寄件者: AI TSANG <[redacted]>
寄件日期: 2026年11月7日星期六 14:51
收件者: Cheryl Tsz Man TSANG/PLAND
主旨: Re: Planning Application No. A/NE-MKT/72 - Proposed Temporary Warehouse for Storage of Car Parts (Coaches Only) and Associated Filling of Land for a Period of 3 Years
附件: all in one 1.pdf

MKT72 . Response to PD comments

YING SHING (HOPEWELL) ENGINEERING CO.LTD.	Layout Plan	Annex 1
	Scale 1:1000 0 10 20 30 40 50 m	October 2026

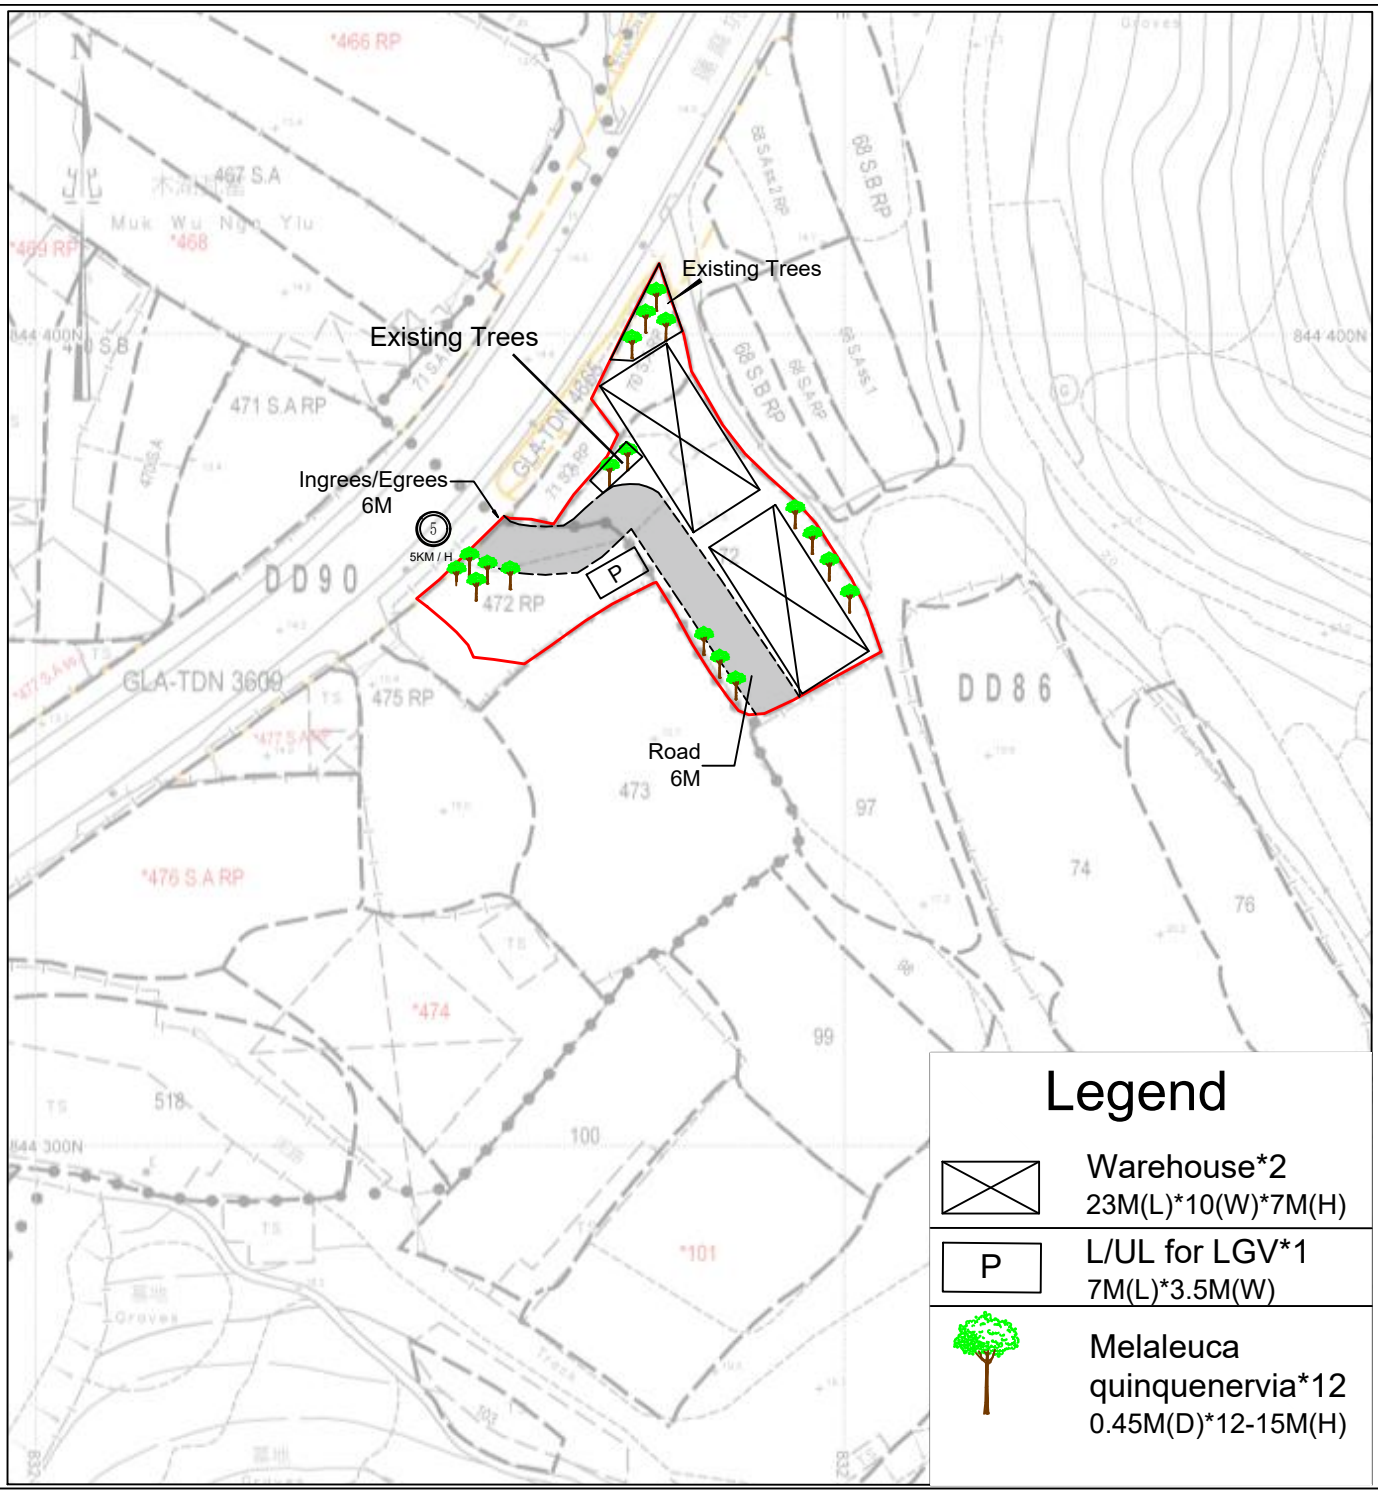
Comment 1
A minor portion of the application site (i.e. Lot 472 RP in D.D. 90) encroaches onto the adjoining site covered by a valid planning permission under application No. A/NE-MKT/49 for temporary vehicle repair workshop and open storage of vehicles (coaches only) with ancillary facilities. The applicant is required to provide justifications for the overlapped area and clarify whether the encroachment would affect the operation of the adjoining vehicle repair workshop; and
The applicant had reviewed the site area and reduced the area from 1335m2 to 1235 m2. **Please refer to related drawing plans.**

Total Site Area: 1235㎡(About)

YING SHING (HOPEWELL) ENGINEERING CO.LTD.	Fence Plan	Annex 2
	Scale 1:1000 0 10 20 30 40 50 m	October 2026

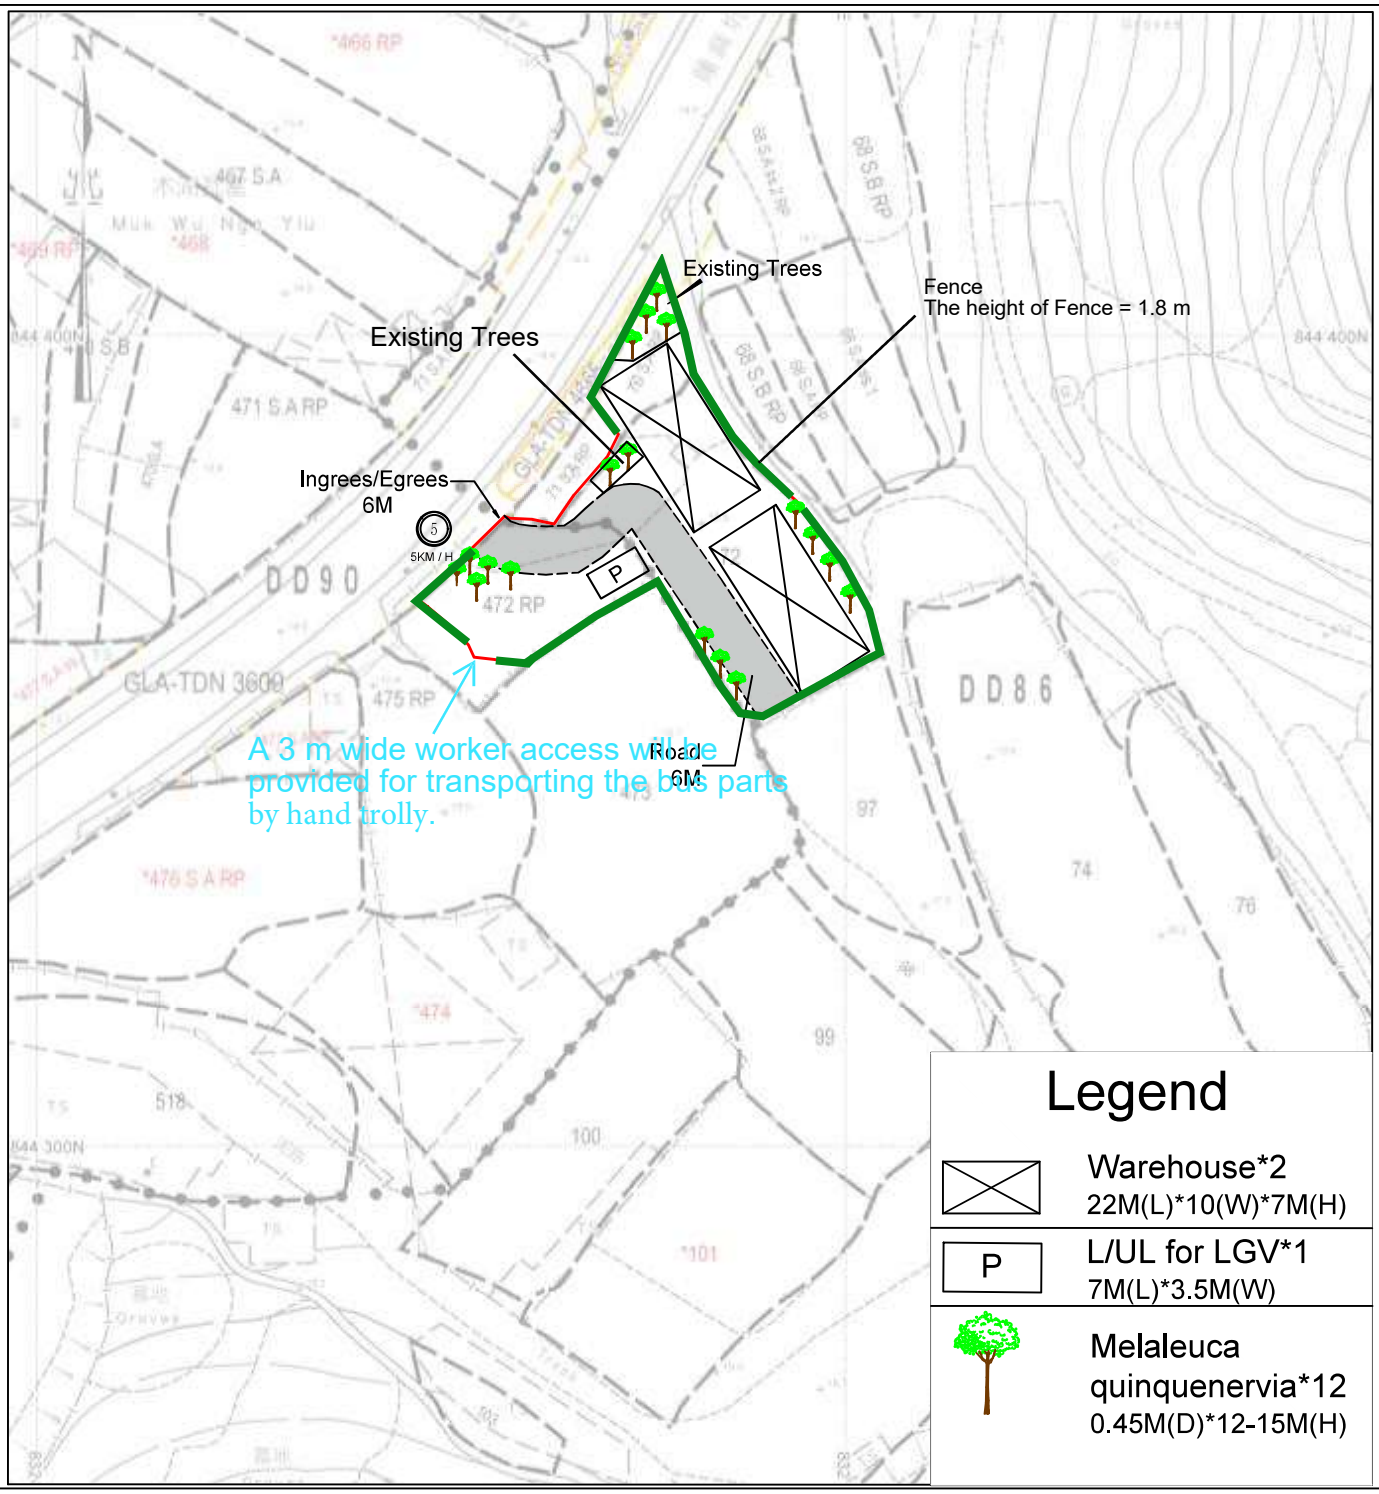
Comment 2
The applicant should clarify whether the application site (the Site) would be fenced-off, such that the only access point of the Site is via Lin Ma Hang Road.
Response
1. There is only one vehicle access point of the site via Lin Ma Hang Road. 2. The site would partly fence-off. Please refer to fence plan

YING SHING (HOPEWELL) ENGINEERING CO.LTD.	Swept Path Plan	Annex 4
	Scale 1:1000 0 10 20 30 40 50 m	October 2026

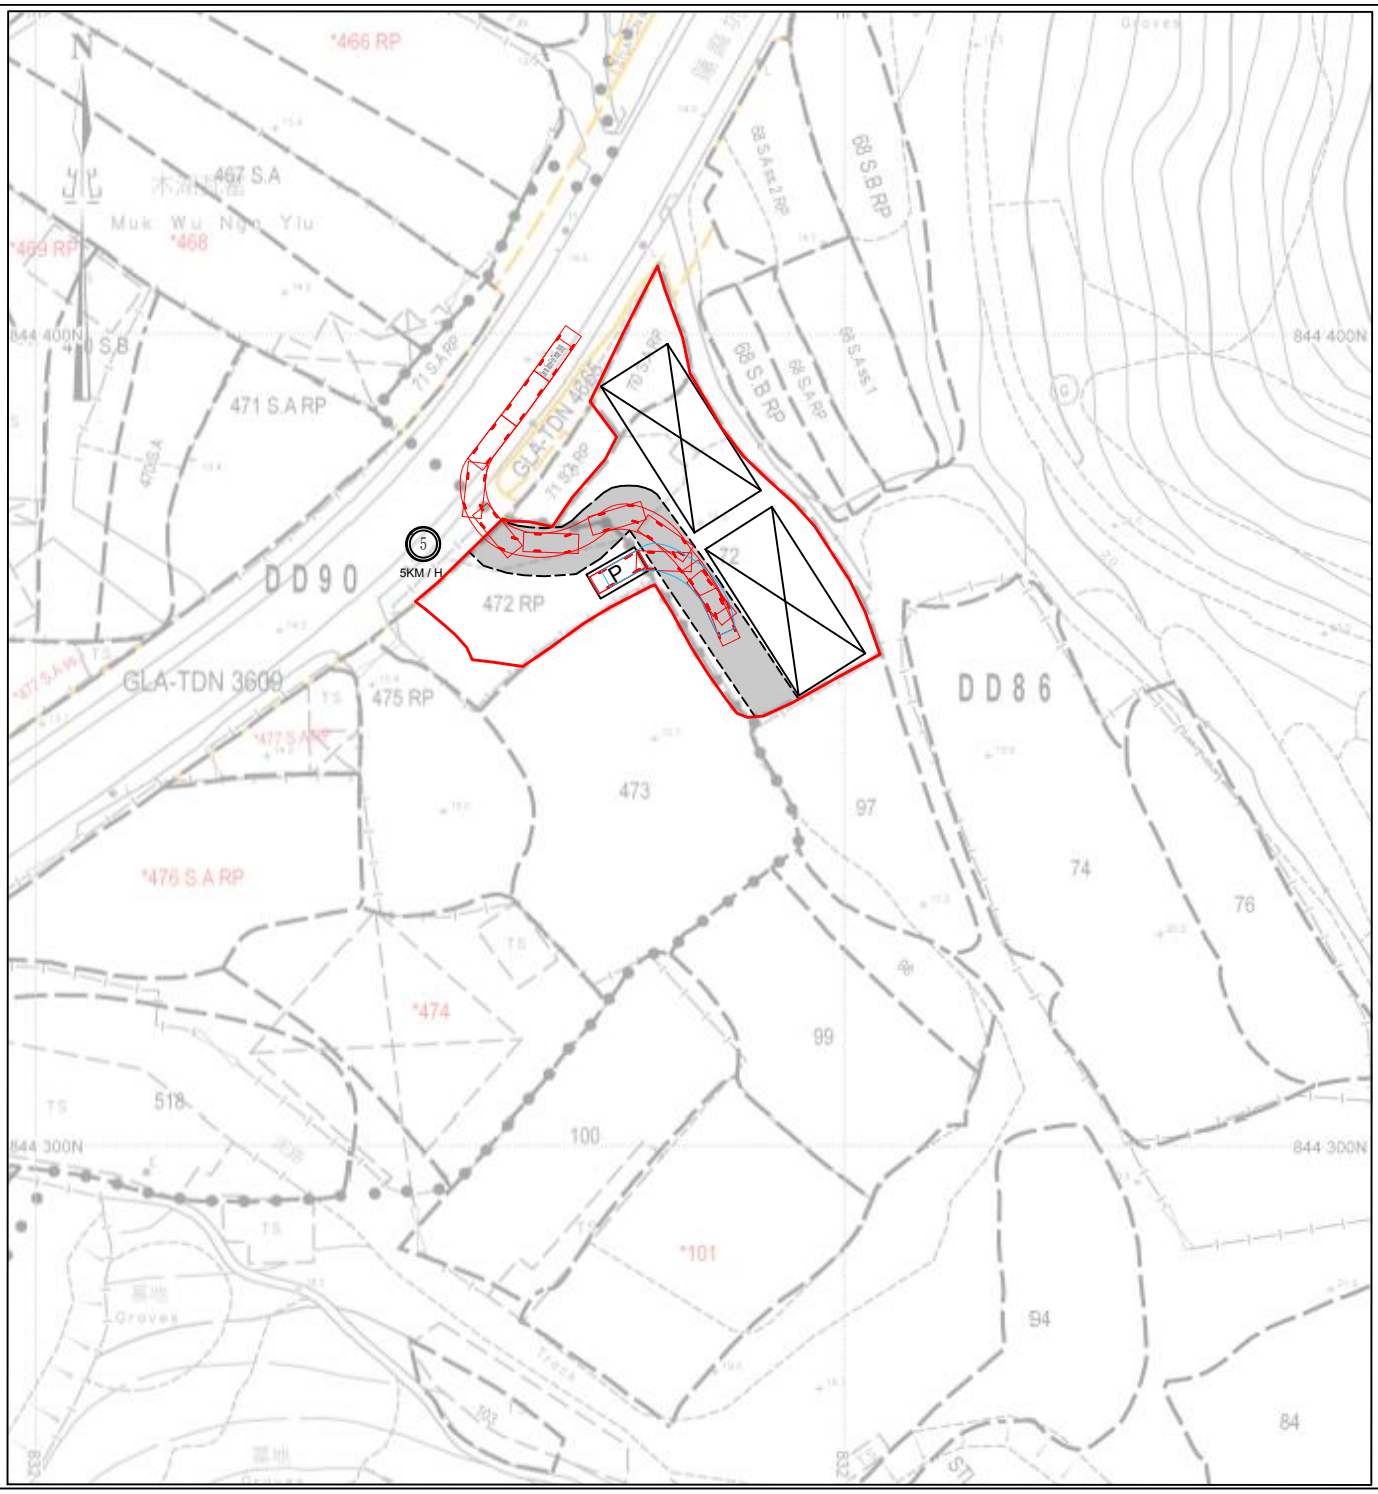
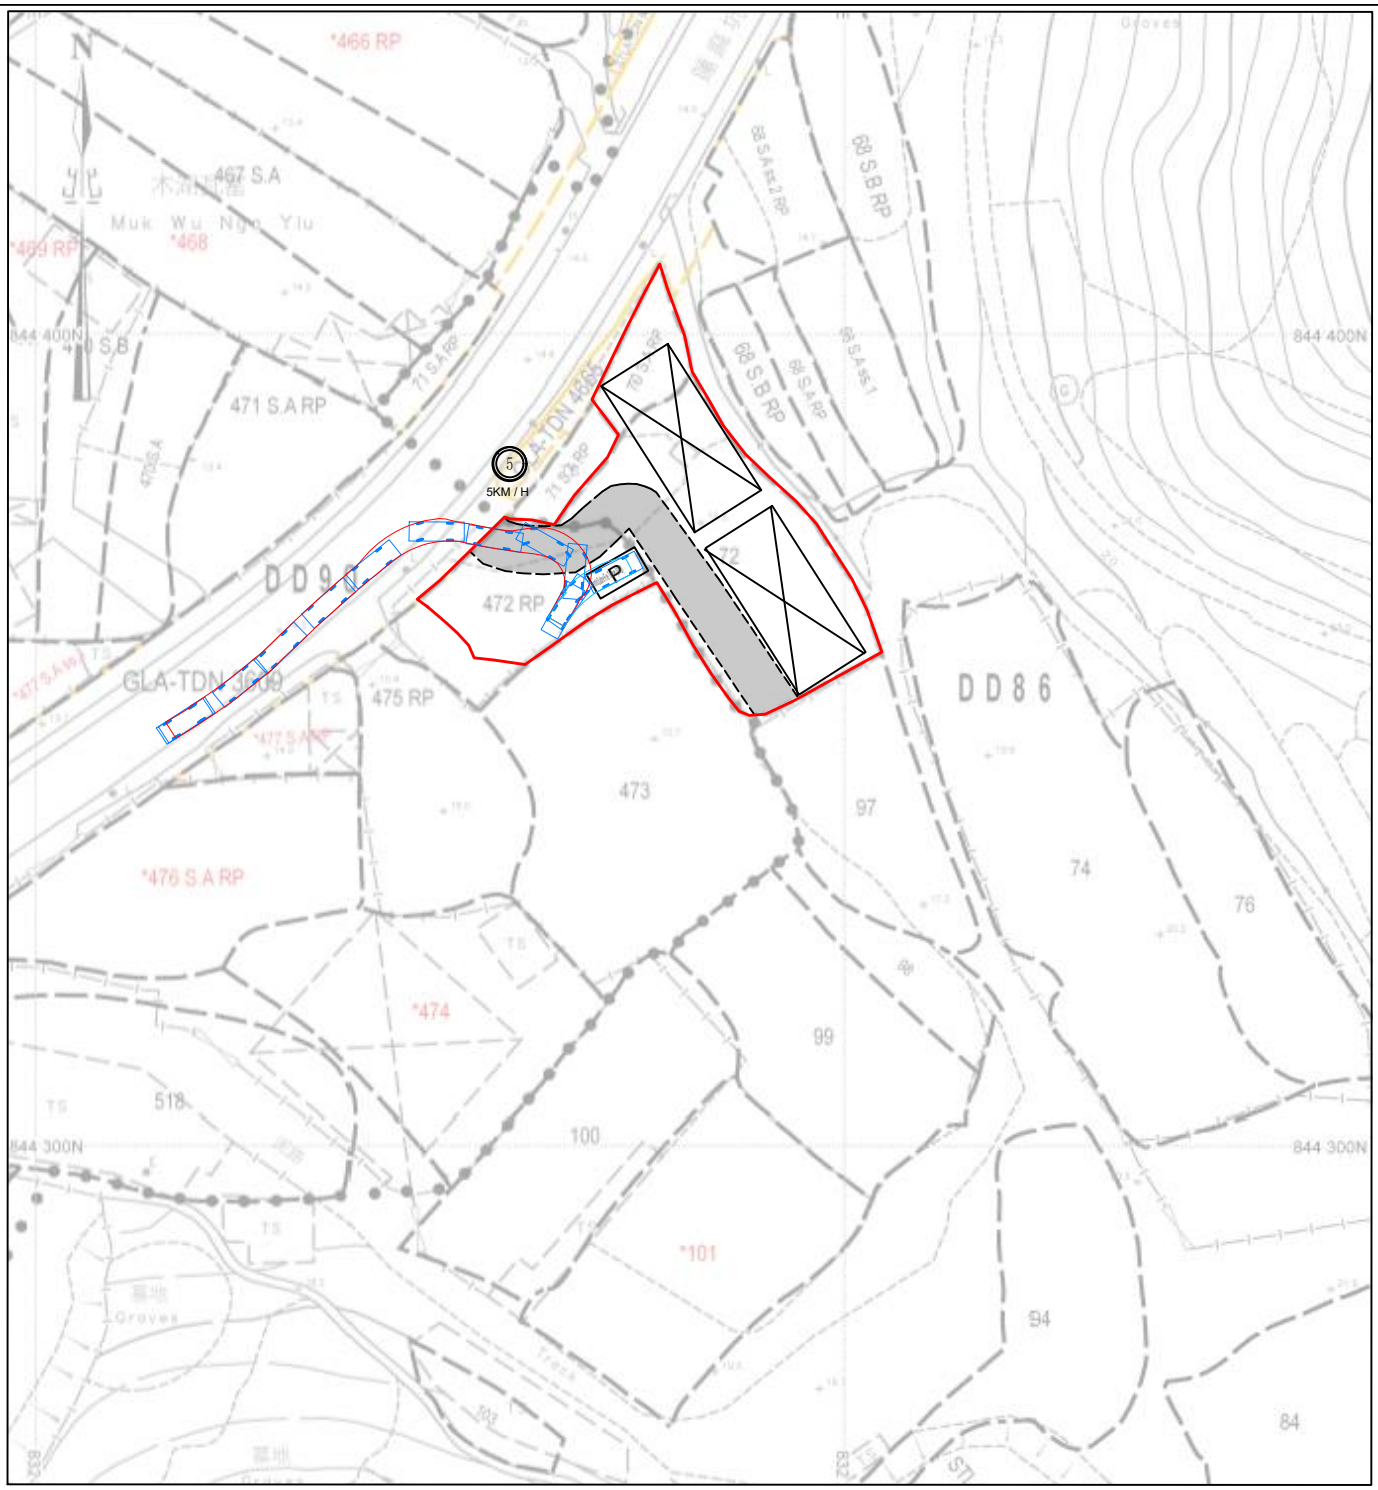
Comment 1
"The applicant shall demonstrate the satisfactory maneuvering of the vehicles exiting the application site without the need to encroach onto the opposite lane preferably using the swept path analysis" has not yet been addressed.
Response
Please refer to swept path plan
